ADDENDUM TO THE CONTRACT

Gastineau Elementary School Renovation

Contract No. E11-137

ADDENDUM NO.: FOUR

SHEET TITLE:	
HEATING PIPING AREA C	
DATE:	NOV 15, 2010
REVISION:
CHECKED BY:	DM
DRAWN:	KB, LH

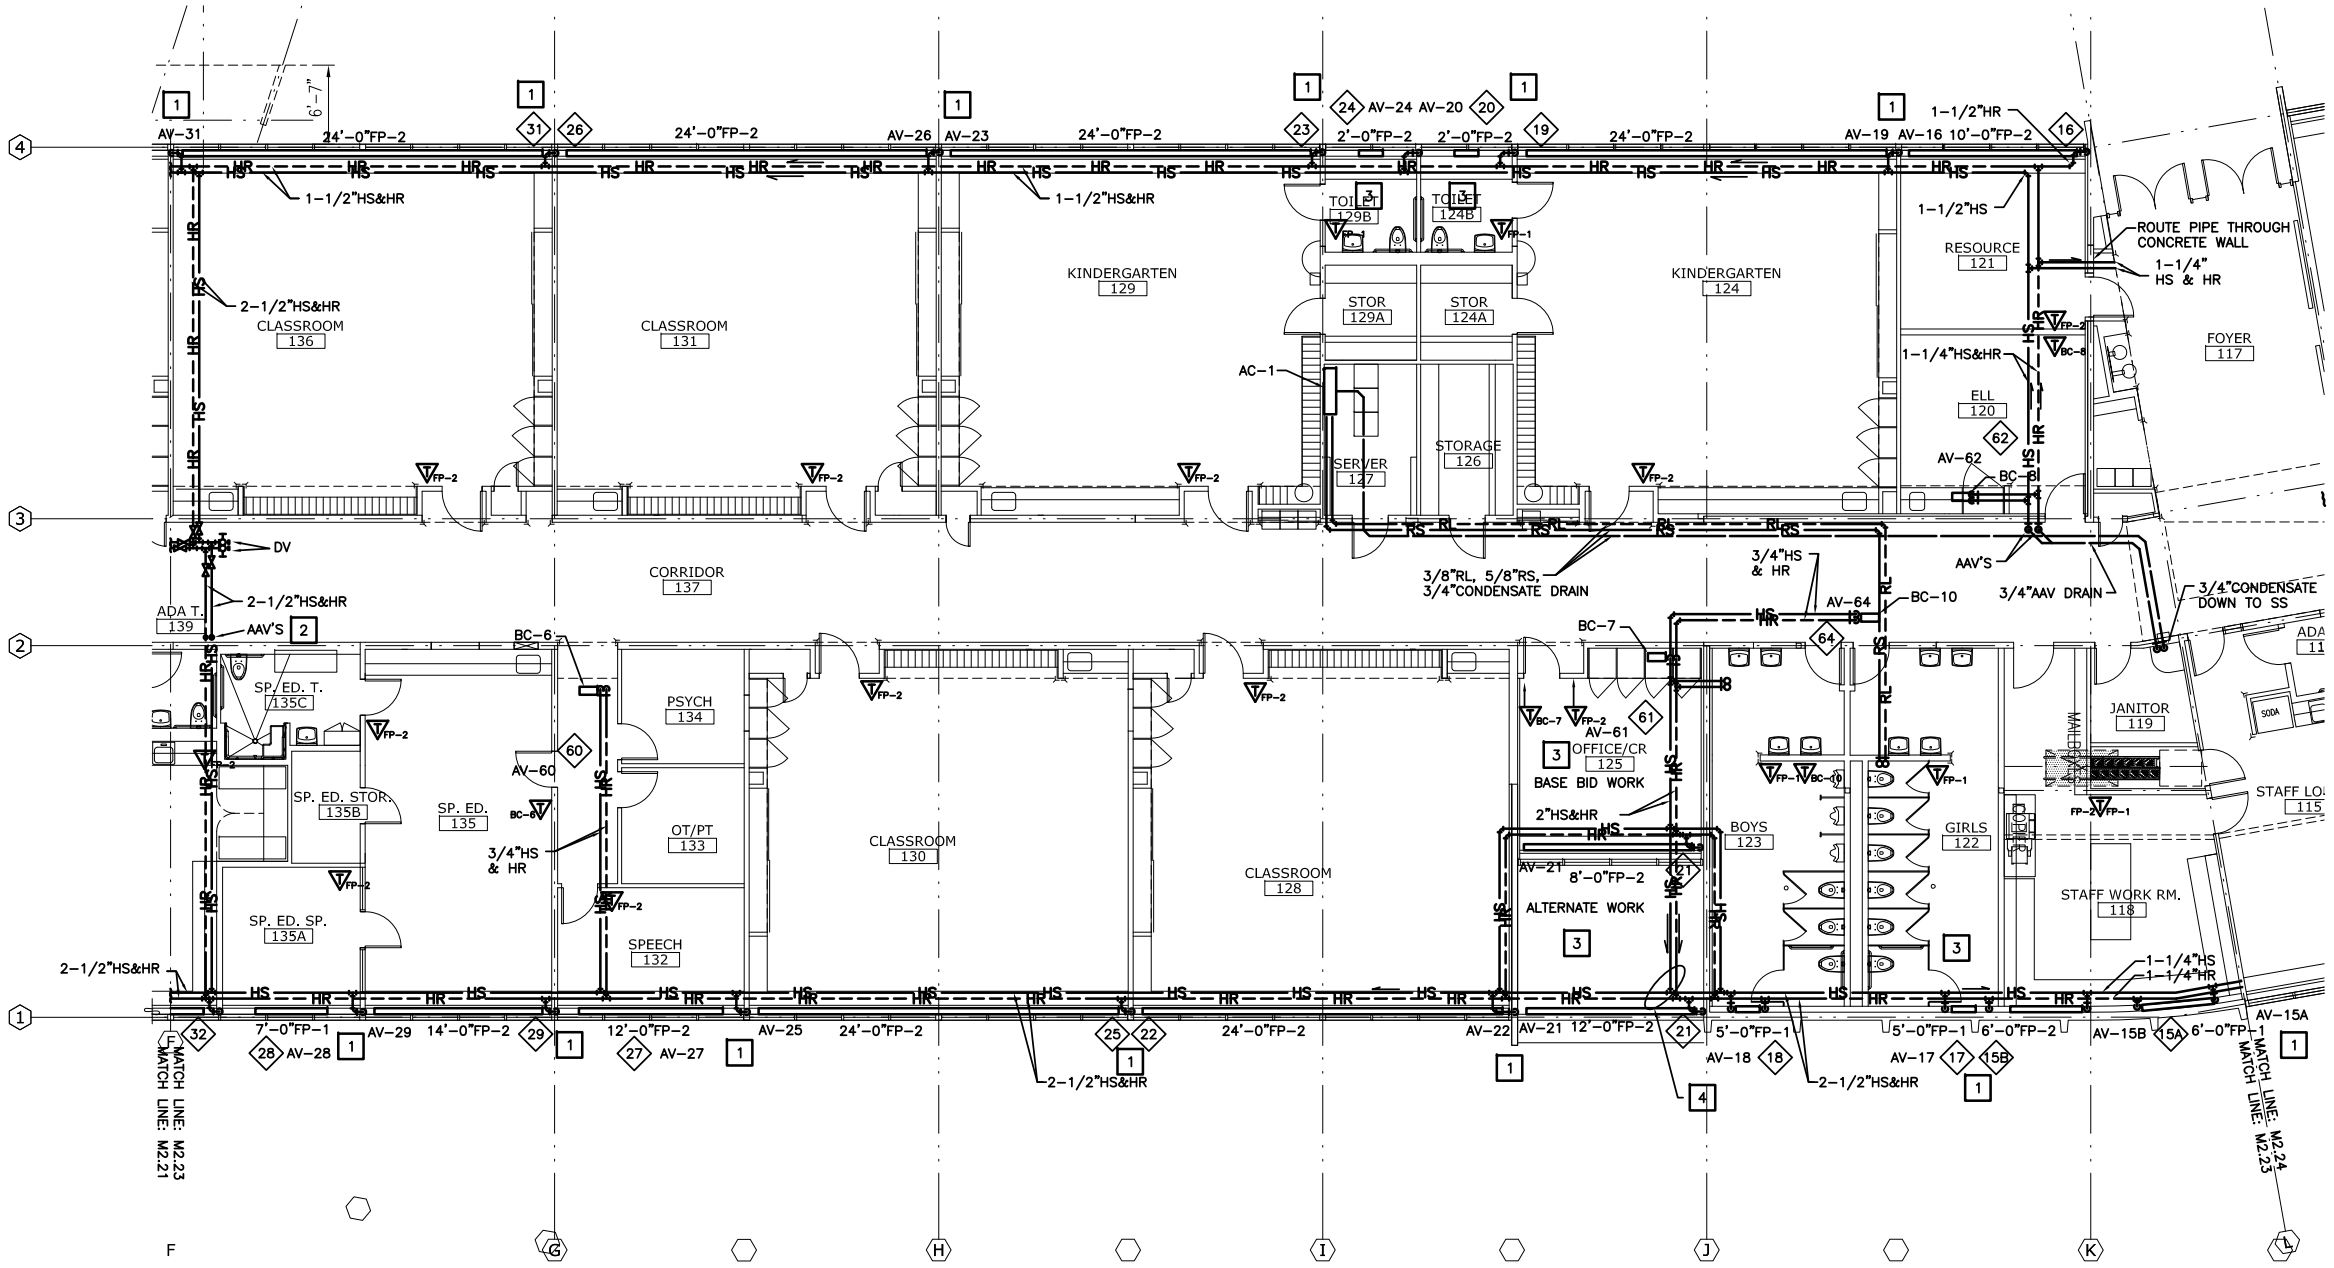
Replace sheet in its entirety with M2.23 included with addendum. This sheet replaced to clarify base bid and alternate piping work.
